## QUALITY ASSURANCE -- NON-CONFORMANCE REPORT

**Report No:** NCR-000527

**NCR #:** ZPMC-0500

**Reference Description:** Longitudinal Indications discovered with MT after the contractor had tested and accepted the welds in Segment 8AE

### Description of Non-Conformance:

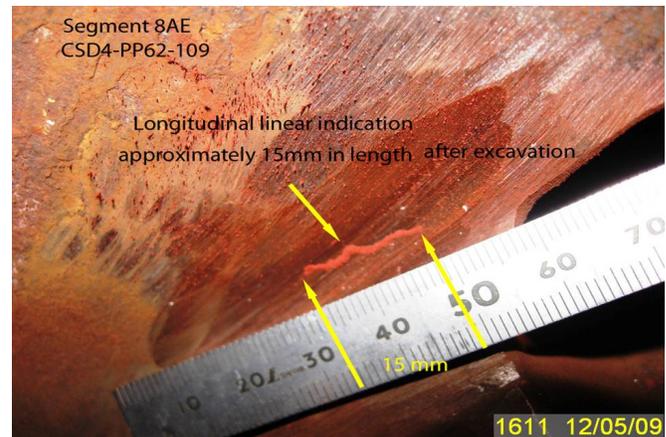
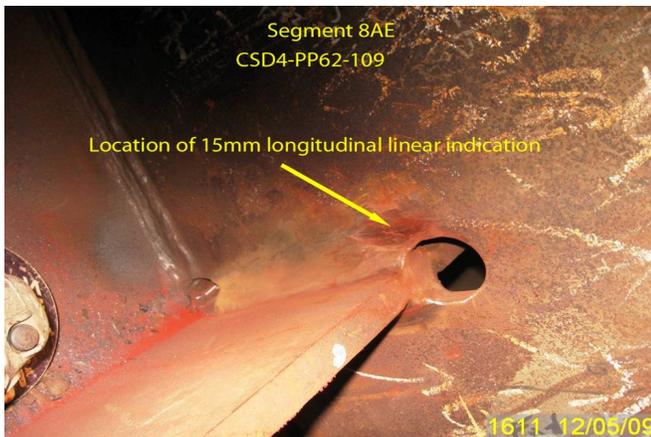
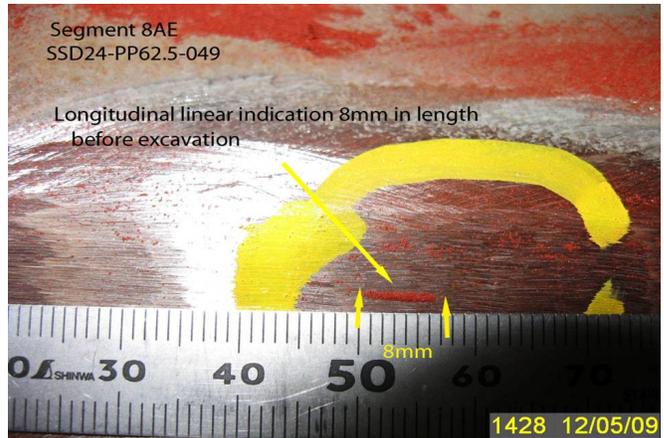
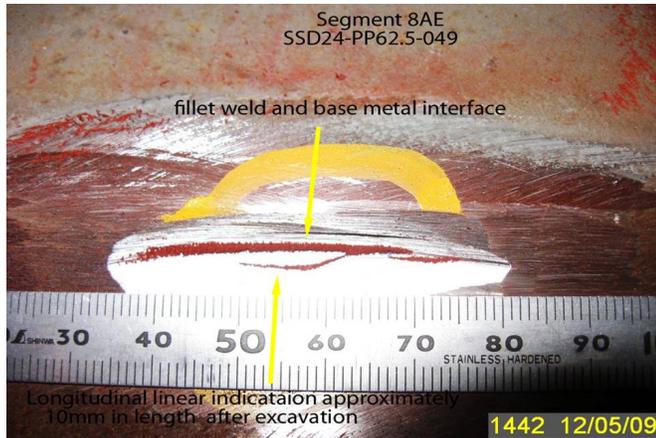
During Quality Assurance Magnetic Particle Testing (MT) review of welds located on Segment 8AE, this Quality Assurance Inspector (QA) discovered the following issues:

-Two (2) Longitudinal linear indications measuring approximately 8mm and 15mm in length. The welds are identified as:

1. SD24-PP62.5-049 @ Panel Point (PP)-062.5 (8 mm indication)
2. CSD4-PP62-109 @ Panel Point (PP)-062 (15 mm indication)

-The Notice of Witness Inspection Number (NWIT) is 004796. The indication is located inside the area that has been previously tested and accepted by ZPMC Quality Control (QC) personnel.

-AWS D1.5 (02) Section 6.26.2 – “Welds that are subject to MT in addition to visual inspection shall have no cracks.

Submit a repair procedure to the engineer for approval. Missed MT indications by ZPMC QC are a chronic problem. Perform training with MT technicians and test for competency to ensure the quality of MT inspection can achieve consistently accurate results. A response for the resolution of this issue is expected within 7 days.

ZPMC has acknowledged the missed MT indication, has generated an internal NCR, performed repairs and re-inspected the welds. ABF QCM has performed updated training to MT operators as a means to prevent re-currence. See attached documentation. ZPMC requests closure of this NCR.

Documentation received is sufficient to close this NCR. Panel Point correction accepted.

**Description of Non-Conformance:**

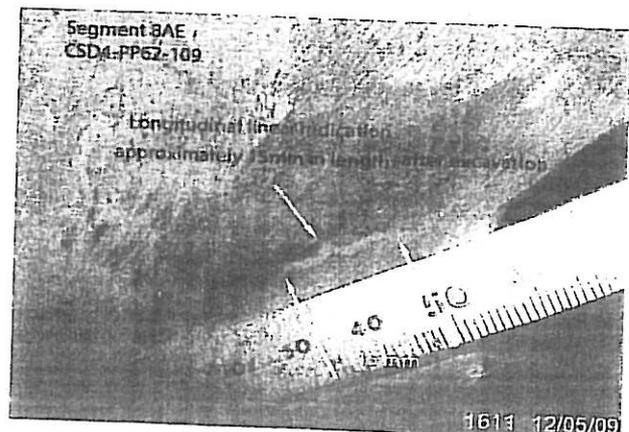
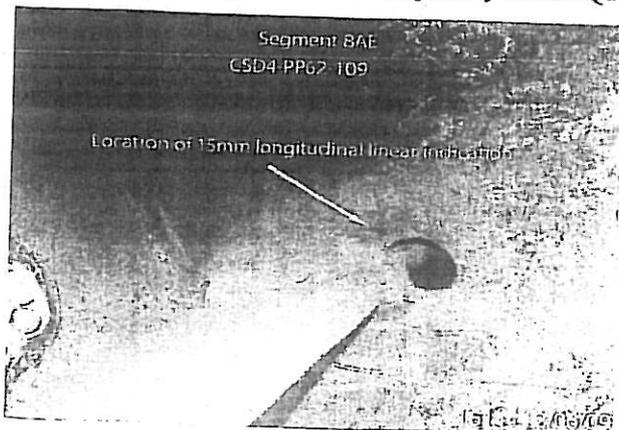
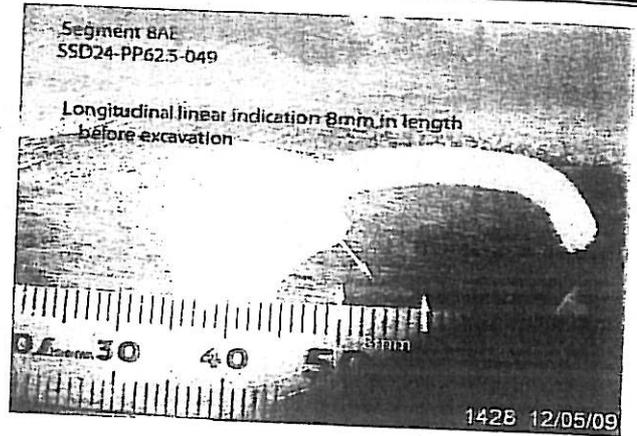
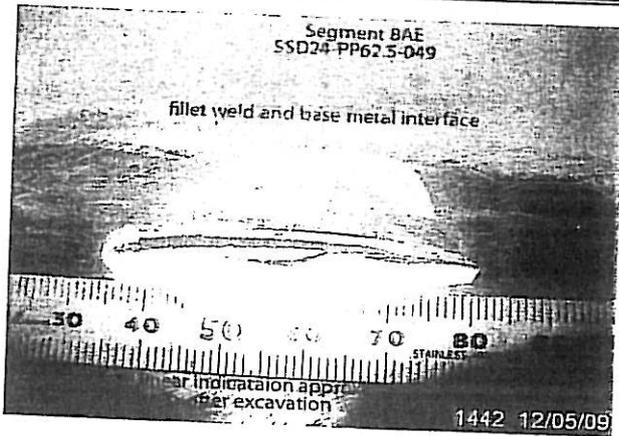
During Quality Assurance Magnetic Particle Testing (MT) review of welds located on Segment 8AE, this Quality Assurance Inspector (QA) discovered the following issues:

-Two (2) Longitudinal linear indications measuring approximately 8mm and 15mm in length. The welds are identified as:

1. SD24-PP62.5-049 @ Panel Point (PP)-062.5 (8 mm indication)
2. CSD4-PP62-109 @ Panel Point (PP)-062 (15 mm indication)

-The Notice of Witness Inspection Number (NWIT) is 004796. The indication is located inside the area that has been previously tested and accepted by ZPMC Quality Control (QC) personnel.

-AWS D1.5 (02) Section 6.26.2 – “Welds that are subject to MT in addition to visual inspection shall have no cracks.

Draft of Welding Discontinuity:

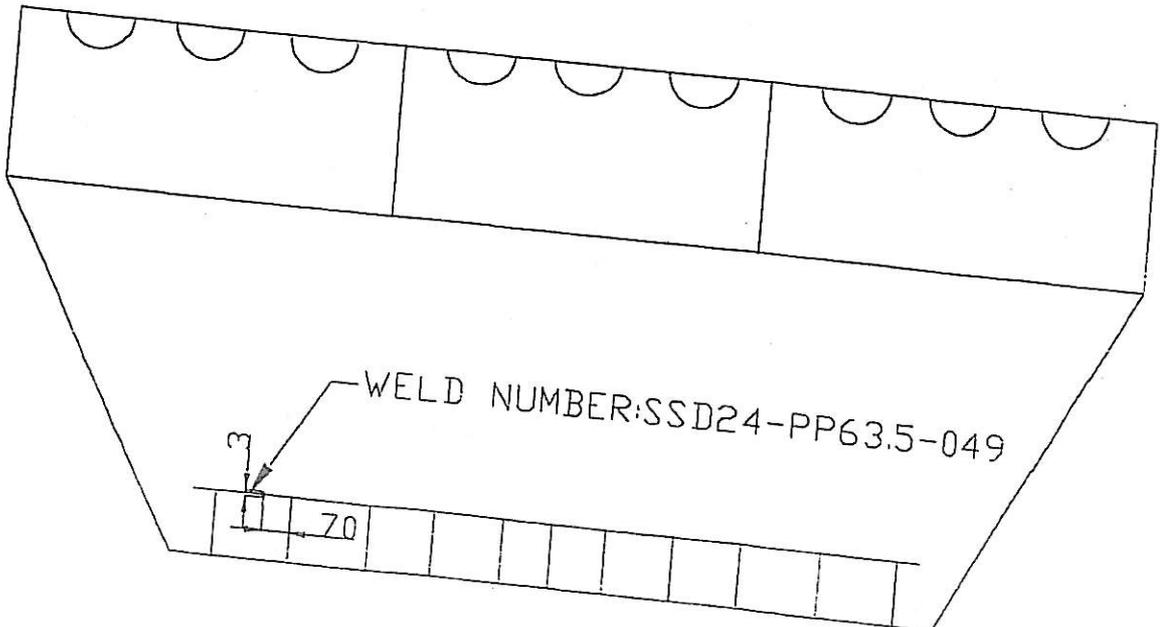
One transverse crack was found by use of MT on SSD24-PP63.5-049.

1. 火焰加热时, 水汽没有完全的去掉或者这个区域预热不够;
1. Moisture wasn't completely removed during drying operation (preheating) or the area wasn't preheated sufficiently.

1. QC and a Lead CWI shall be present, direct and supervise all grinding and welding operations during this repair to ensure the repair is per the disposition requirements

2. QC and a Lead CWI shall have an approved copy of the CWR in hand prior to the repair.

3. Remove paint ≥ 25mm in all direction of HAZ prior to MT.

4. Clean the excavation area of all loose debris including MT powder. Preheat to 65° C before removing cracks by grinding, repair area shall extend a minimum of 50mm beyond each end of single crack repairs.

5. If base metal is damaged by grinding, the damaged area shall be ground clean prior to performing weld repair. If gap > 5mm is found during or after grinding, comply with the notification on changing fillet weld to CJP which is submitted for Engineer's review and approval form.

6. Prepare excavation in accordance with the New Repair Procedure prior to welding.

7. Before this repair, Verify with VT and MT repair areas are defects free, and also MT shall be performed on the base metal laying abroad cracks to ensure that no cracks were propagated to the base metal. Separate CWR approval is needed if cracks are found in the base metal, and only after this new CWR's approval can continue the repair.

8. Clean excavation area of all loose debris including MT powder after excavation. Preheat and weld according to repair WPS, the preheat shall between 160° C-230° C.

9. Perform post weld heating according to repair WPS, the postheat shall between 230° C-315° C and for one hour minimum.

10. Allow the weld to cool to ambient temperature gradually. Control cooling rate after PWHT to no more than 50° C per hour.

11. Grind the repaired area flush with base metal or the adjacent weld after post weld heating.

12. Wait 48 hours at least after the repair area has cooled to ambient temperature before performing NDT.

13. Perform MT inspection to all repair area according to Contract Drawings along with all additional NDT required by the applicable notes Special Provision Section 10-1.59 'Steel Structure', subsection 'inspection testing'. NDT include VT, MT and UT if it is a CJP weld.

### Draft of Welding Discontinuity:

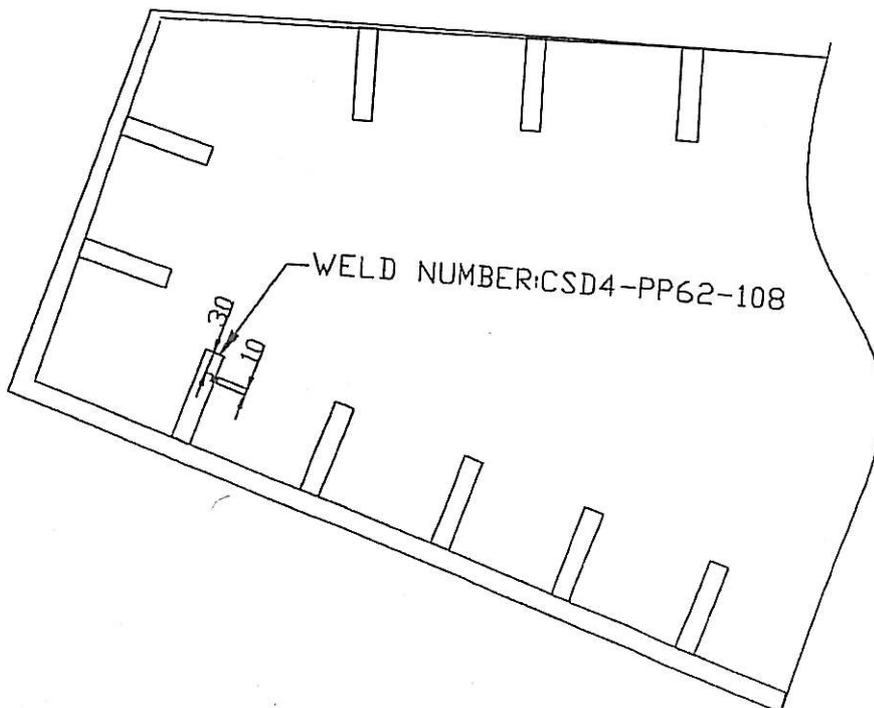
One longitudinal crack was found by use of MT on CSD4-PP62-108.

1. 火焰加热时, 水汽没有完全的去掉或者这个区域预热不够;
1. Moisture wasn't completely removed during drying operation (preheating) or the area wa sn't preheated sufficiently.

1. QC and a Lead CWI shall be present, direct and supervise all grinding and welding operations during this repair to ensure the repair is per the disposition requirements

2. QC and a Lead CWI shall have an approved copy of the CWR in hand prior to the repair.
3. Remove paint  $\geq 25\text{mm}$  in all direction of HAZ prior to MT.

4. Clean the excavation area of all loose debris including MT powder. Preheat to 65° C before removing cracks by grinding, repair area shall extend a minimum of 50mm beyond each end of single crack repairs.

5. If base metal is damaged by grinding, the damaged area shall be ground clean prior to performing weld repair. If gap  $> 5\text{mm}$  is found during or after grinding, comply with the notification on changing fillet weld to CJP which is submitted for Engineer's review and approval form.

6. Prepare excavation in accordance with the New Repair Procedure prior to welding.
7. Before this repair, Verify with VT and MT repair areas are defects free, and also MT shall be performed on the base metal laying abroad cracks to ensure that no cracks were propagated to the base metal. Separate CWR approval is needed if cracks are found in the base metal, and only after this new CWR's approval can continue the repair.

8. Clean excavation area of all loose debris including MT powder after excavation. Preheat and weld according to repair WPS, the preheat shall between 160° C-230° C

9. Perform post weld heating according to repair WPS, the postheat shall between 230° C-315° C and for one hour minimum.
10. Allow the weld to cool to ambient temperature gradually. Control cooling rate after PWHT to no more than 50° C per hour.

11. Grind the repaired area flush with base metal or the adjacent weld after post weld heating.
12. Wait 48 hours at least after the repair area has cooled to ambient temperature before performing NDT.

13. Perform MT inspection to all repair area according to Contract Drawings along with all additional NDT required by the applicable notes Special Provision Section 10-1.59 'Steel Structure', subsection 'inspection testing'. NDT include VT, MT and UT if it is a CJP weld.
